Subject: Submittal Supporting Accelerated ABWR Review Schedule - **DFSER**  
**Chapters 3 and 6 Outstanding Items and Question Response**

Enclosed are SSAR markups addressing Confirmatory Items 3.6.1-2 and 6.2.1.7-1, and response to Open Item 6.2.1.6-3. In addition, the response to a question on Subsection 6.2.1.2.2 Design Features is enclosed.

### **DFSER OPEN ITEM 6.2.1.6.3: CONTAINMENT MODELING CONCERN**

Response to Question  
on subsection 6.2.1.2.2

FIGURE 6.2-37A. SECONDARY CONTAINMENT SCHEMATIC FLOW DIAGRAM.  
(EMERGENCY CORE COOLING/REACTOR CORE ISOLATION COOLING)

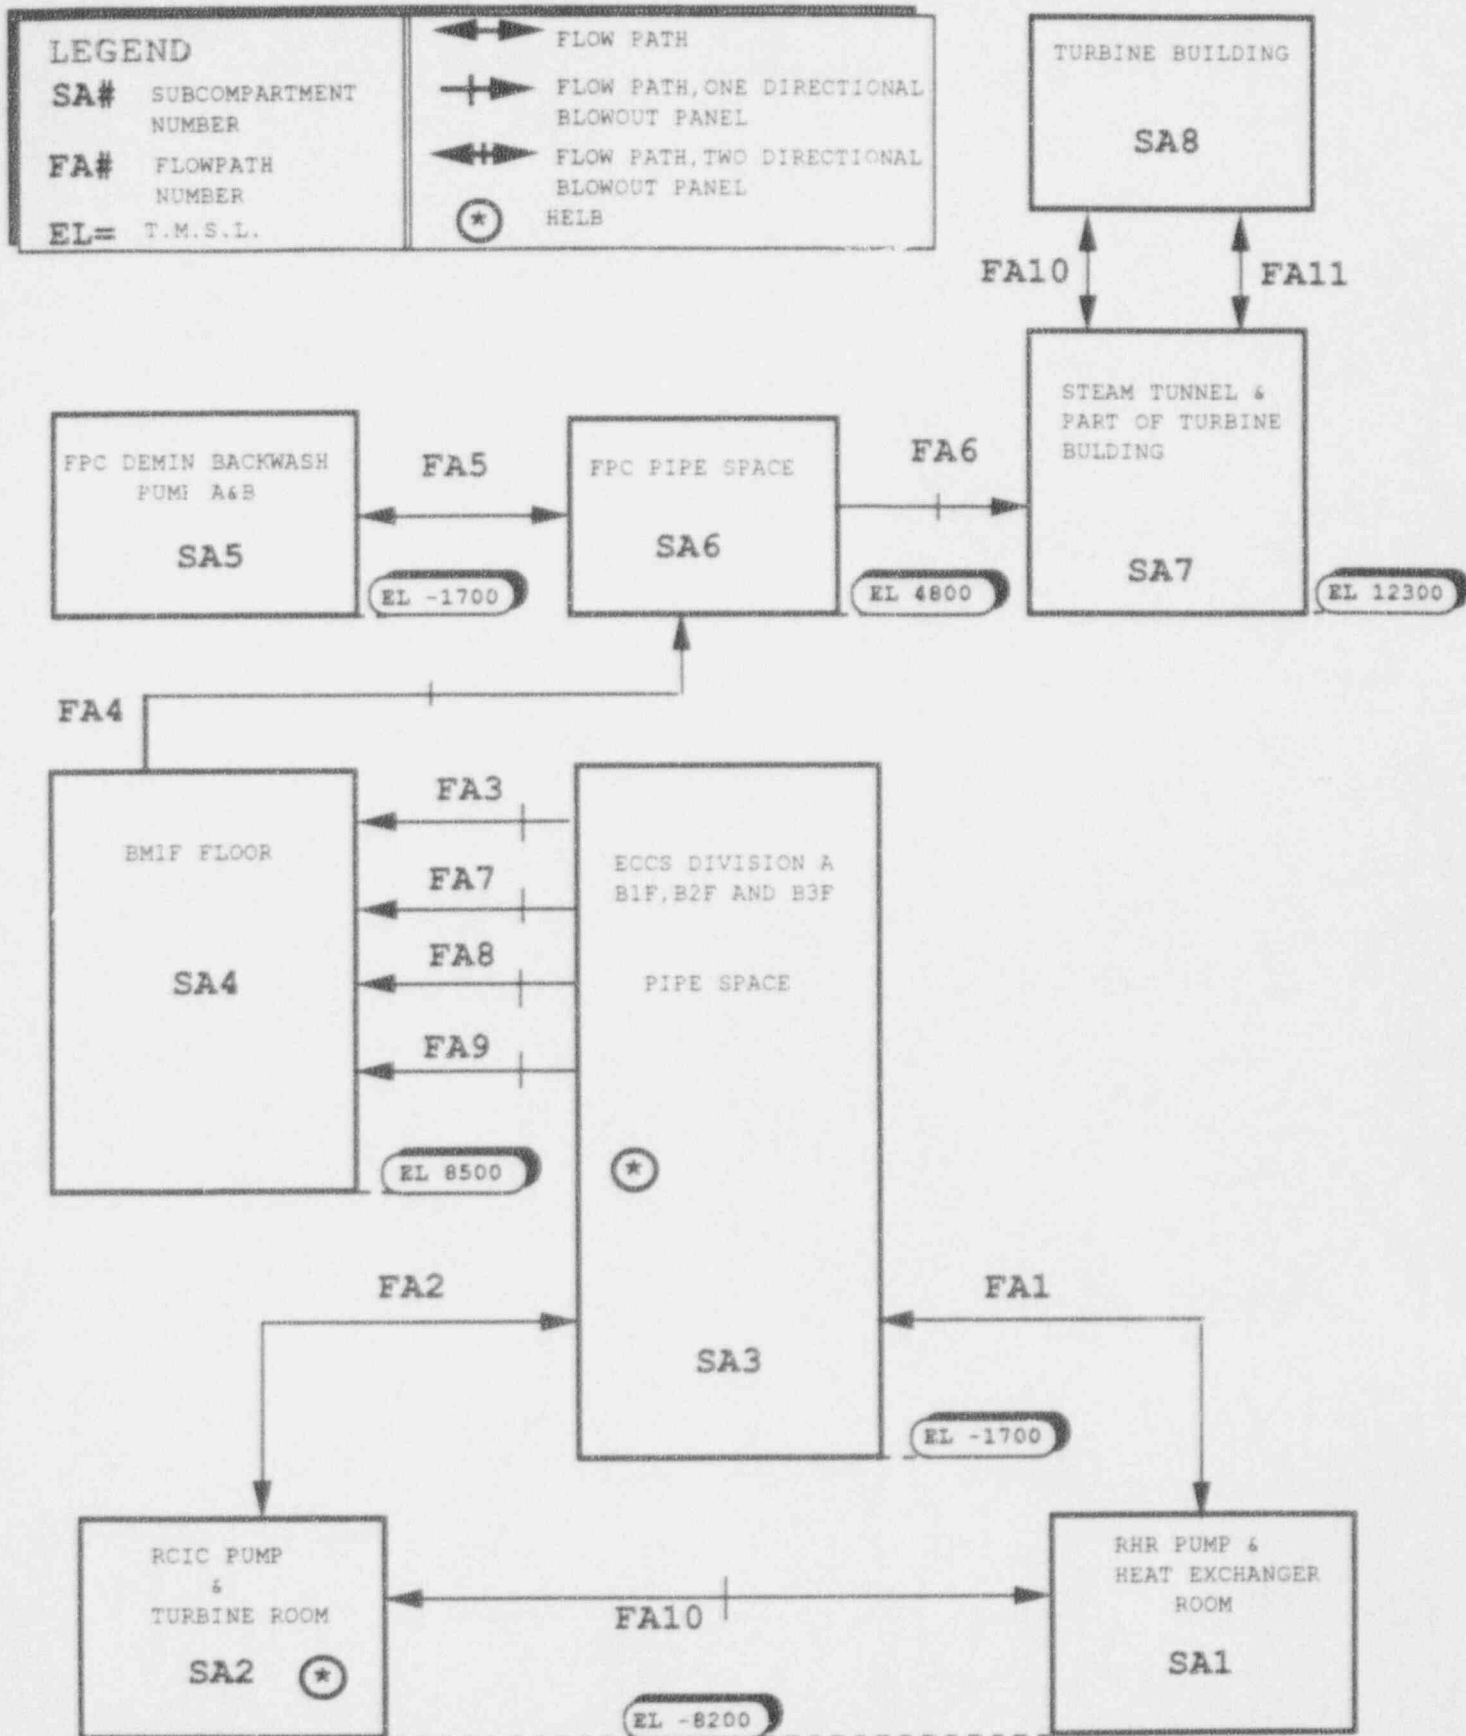
Figure 6.2.-37A shows the compartment nodalization scheme used for the pressurization analysis model for different break cases. Table 6.2.3 shows the free volume, initial environmental conditions and DBA characteristics for the compartments which were analyzed. Table 6.2-4 tabulates subcompartment vent path characteristic. The calculated peak differential pressures for the RCIC compartments are tabulated in Table 6.2-3.

Break in subcompartment SA2  
RCIC Pump & Turbine Room  
and in subcompartment SA3  
ECCS Division A B1F, B2F, & B3F  
Pipespace(Figure 6.2.37A)

FIGURE 6.2-37B. SECONDARY CONTAINMENT SCHEMATIC FLOW DIAGRAM.  
(MAIN STEAM/FEEDWATER)

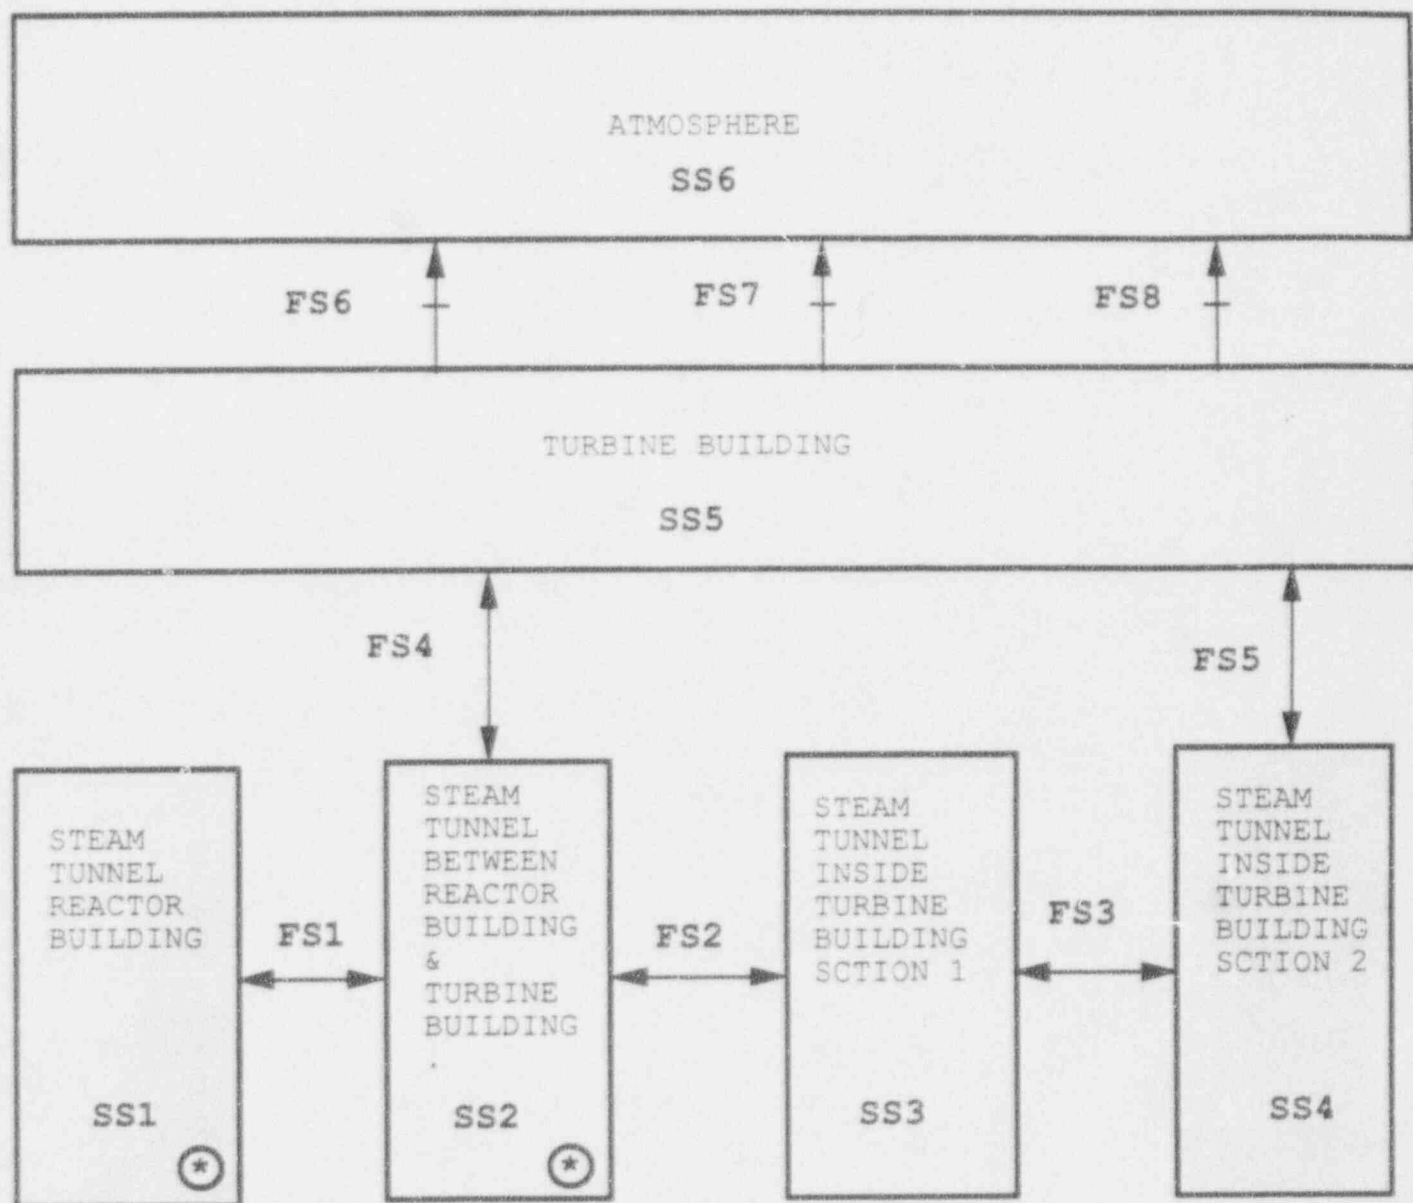
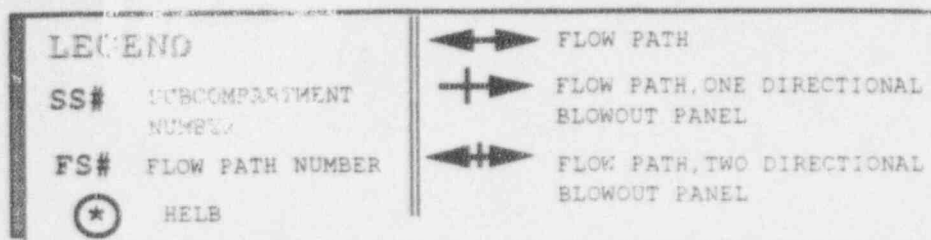
Figure 6.2-37B shows compartment nodalization scheme for the pressurization analyses for different postulated break cases. Table 6.2.3 shows the free volume, initial environmental conditions and DBA characteristics for the compartments analyzed. Table 6.2-4 tabulates subcompartment vent path characteristic. The calculated peak differential pressures for the main steam tunnel compartments are tabulated in Table 6.2-3.

Break in subcompartment  
SS1 (steam tunnel)  
Main Steam Line Break  
(Figure 6.2.37B)

FIGURE 6.2-37C-1. SECONDARY CONTAINMENT SCHEMATIC FLOW DIAGRAM. (REACTOR WATER CLEAN UP SYSTEM)

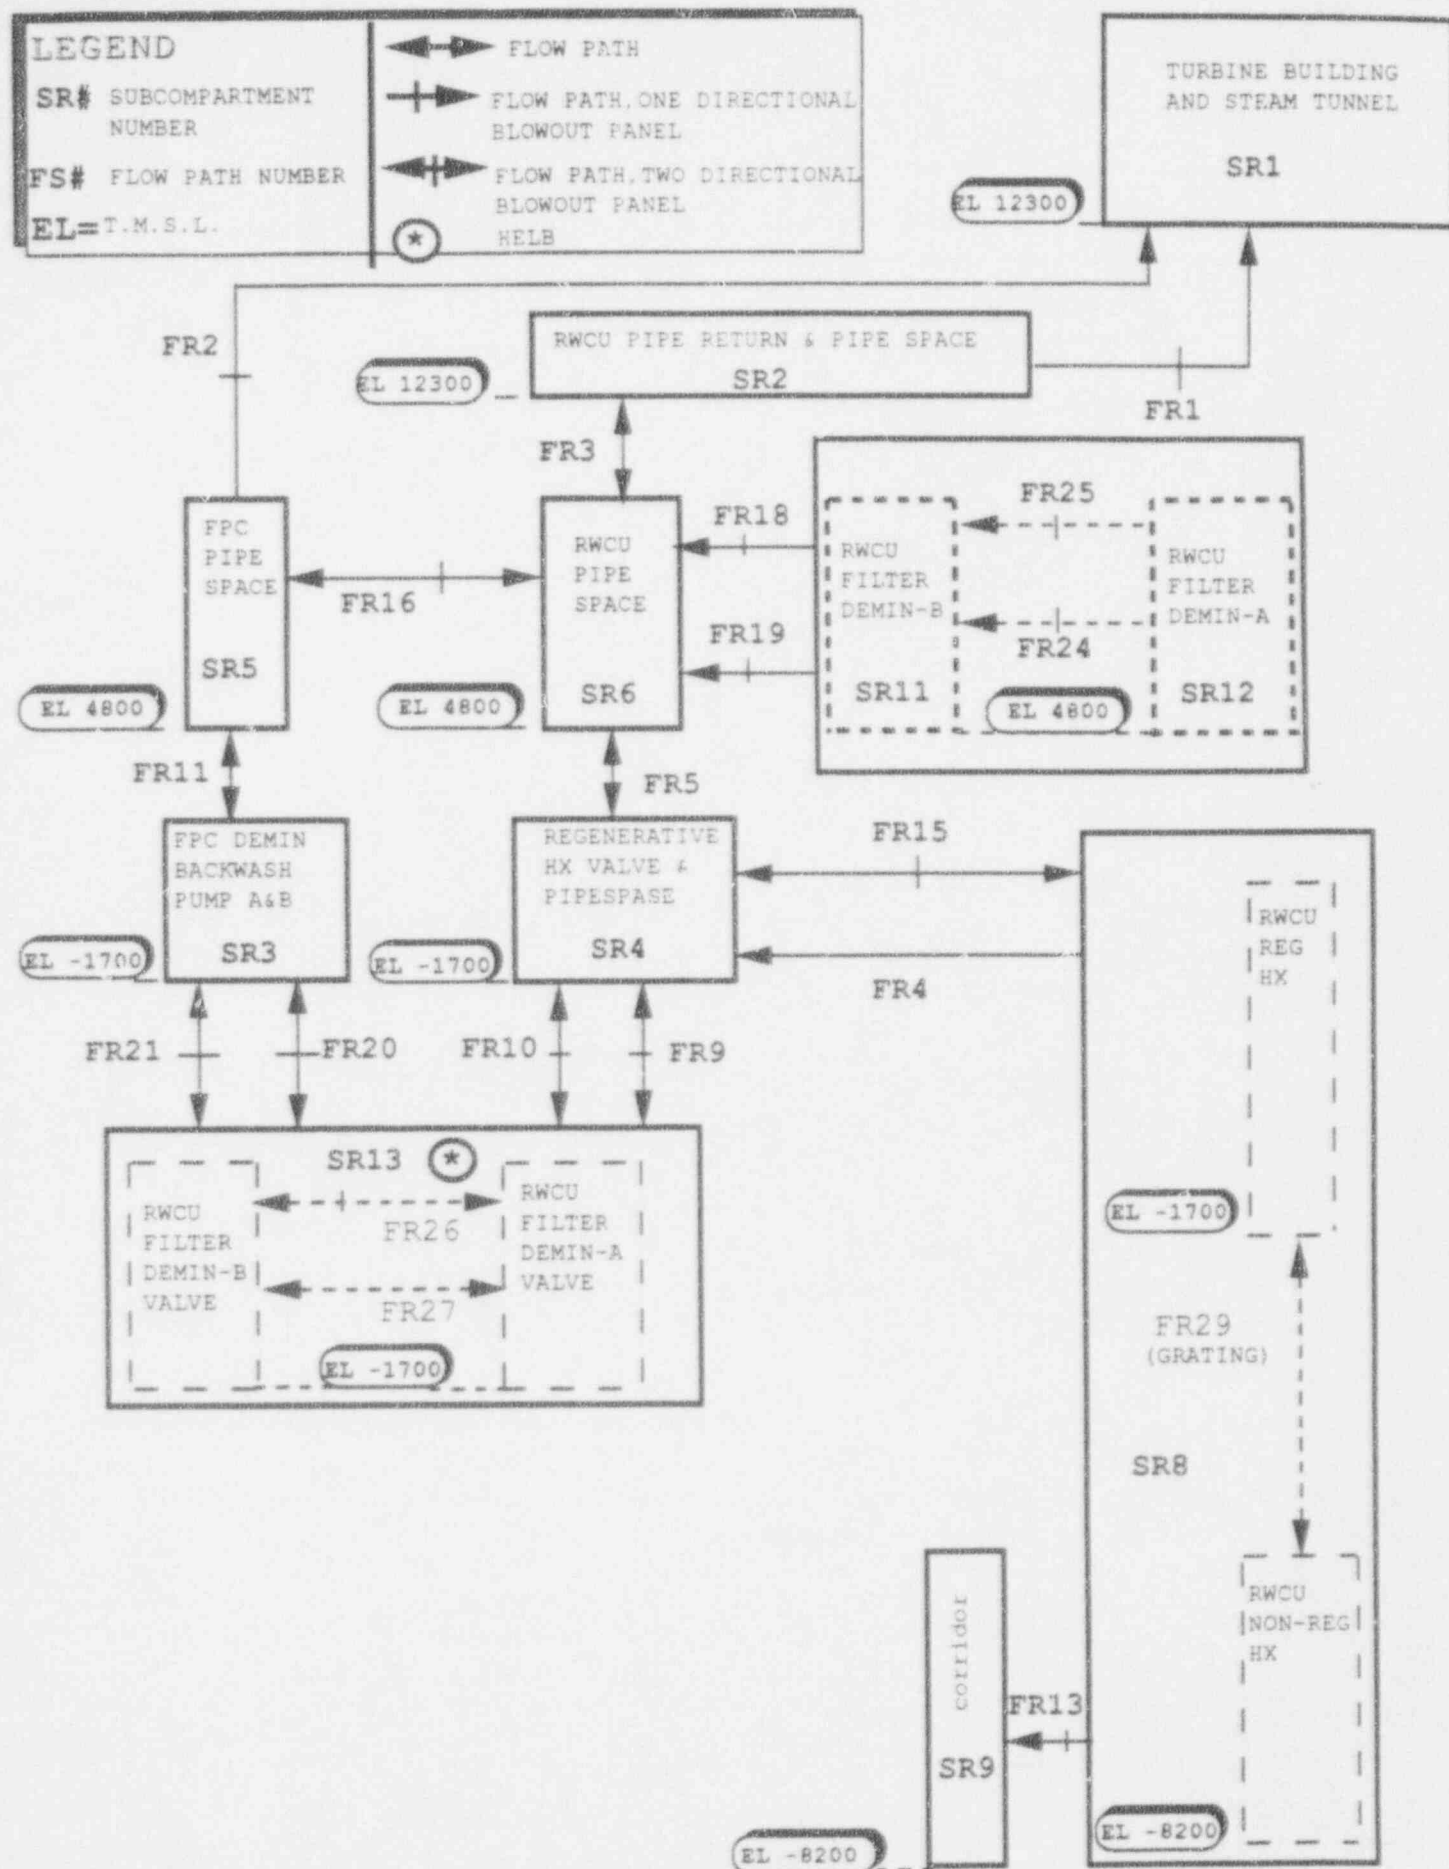
Figures 6.2-37-C1 through 6.2-37-C3 show compartment nodalization scheme for the pressurization analyses for different break cases. Table 6.2-3 shows the free volume, initial environmental conditions and DBA characteristics for the compartments which were analyzed. Table 6.2-4 tabulates subcompartment vent path characteristic. The calculated peak differential pressures for the RWCU compartments are tabulated in Table 6.2-3

Break in subcompartment SR13  
RWCU Filter/Demin A & B Valve Rooms  
(Figure 6.2.37c-1)

FIGURE 6.2-37C-2. SECONDARY CONTAINMENT SCHEMATIC FLOW DIAGRAM (REACTOR WATER CLEAN UP SYSTEM)

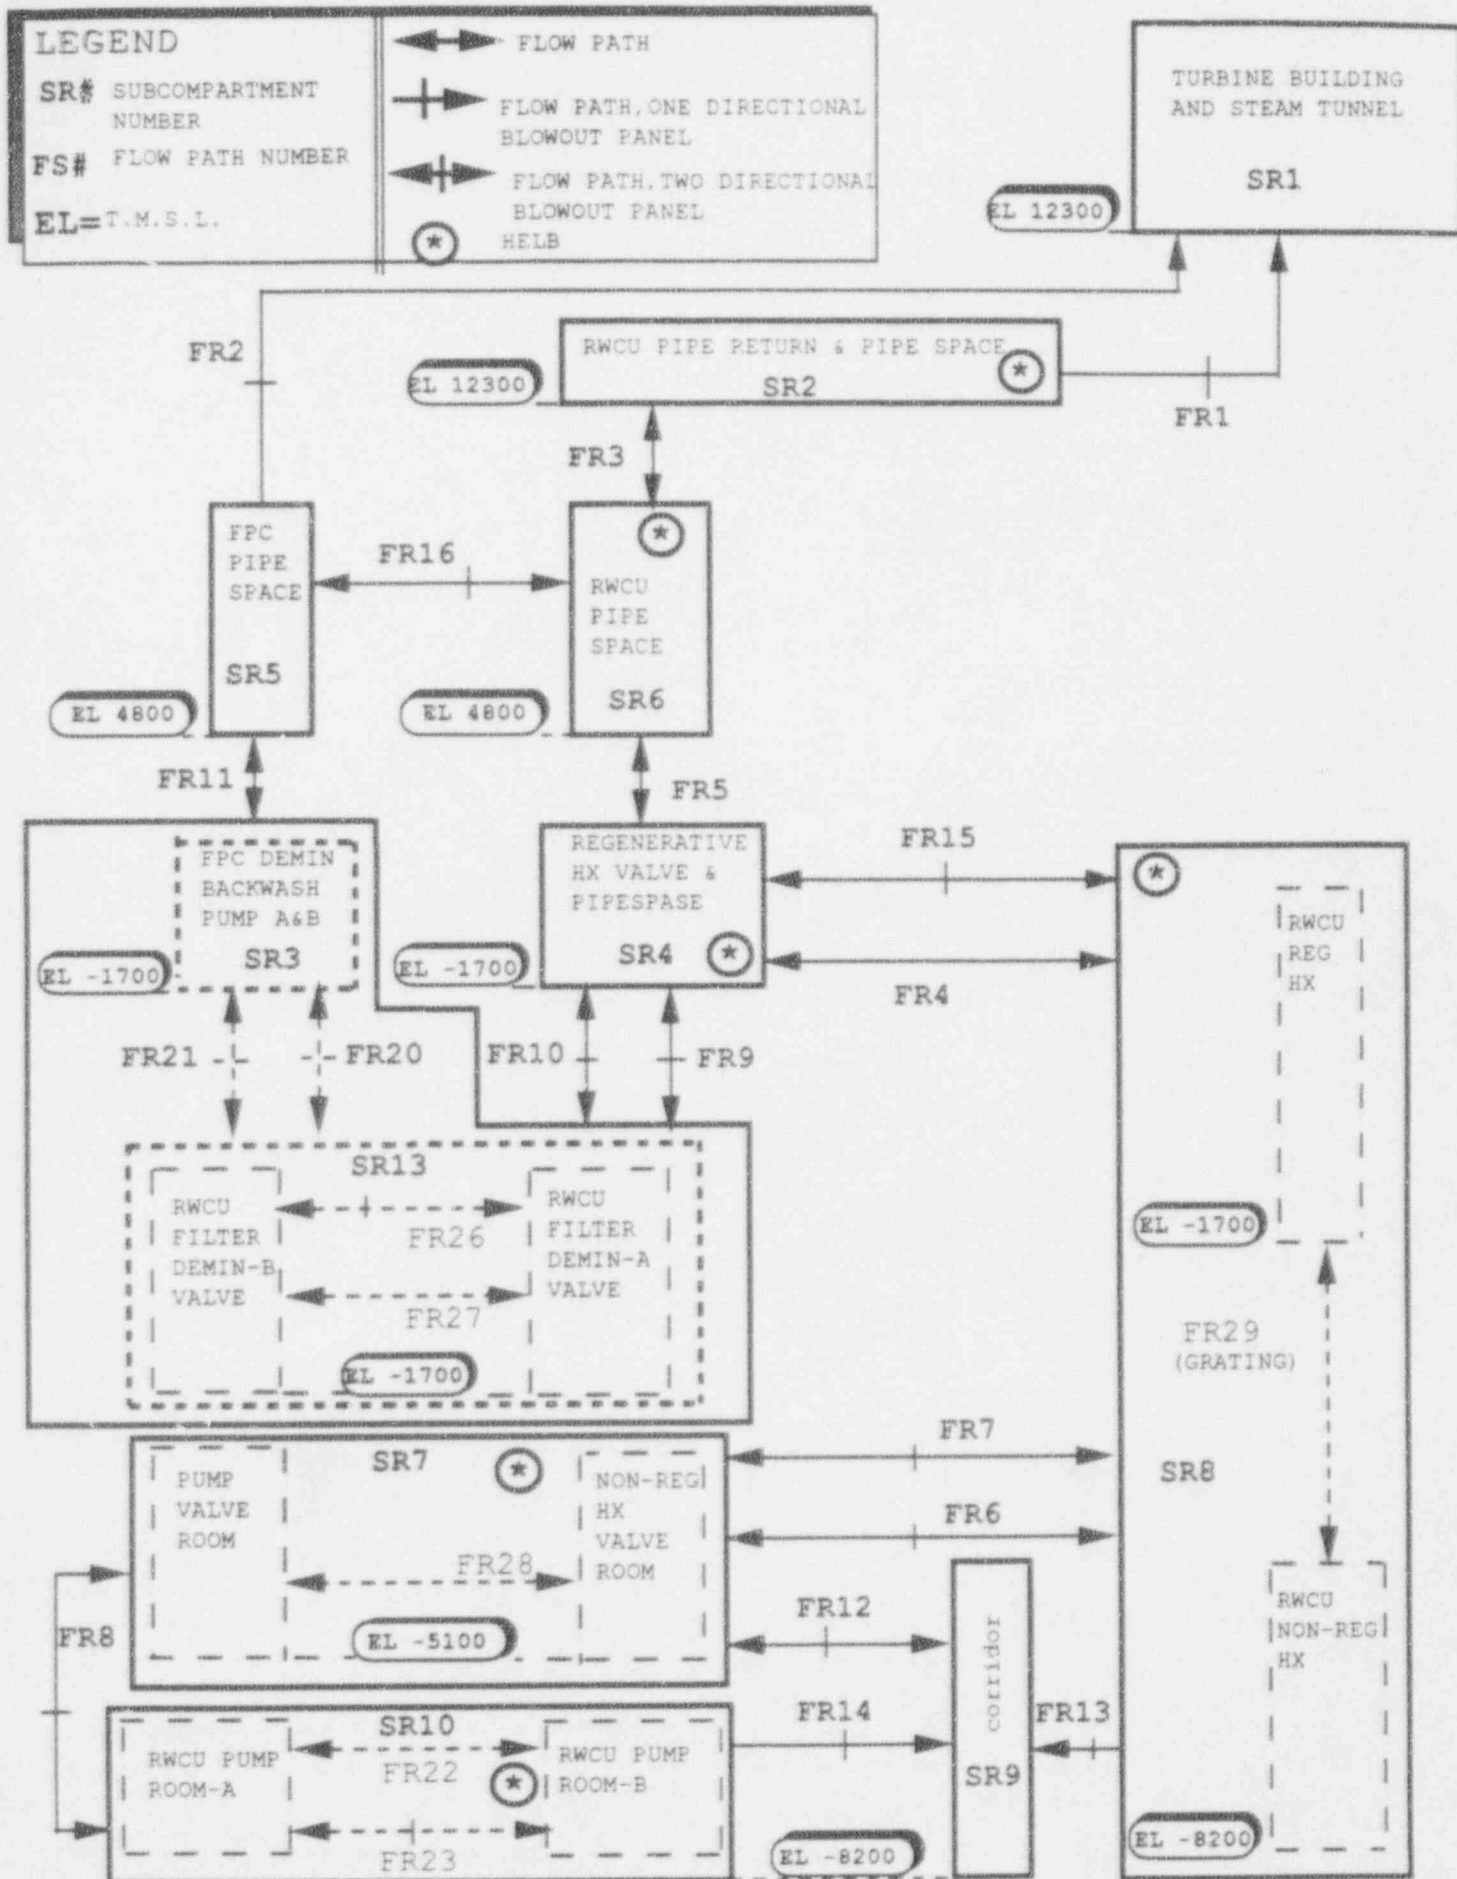
Break in subcompartment SR2  
RWCU Entrance Room  
(Figure 6.2.37c-2)
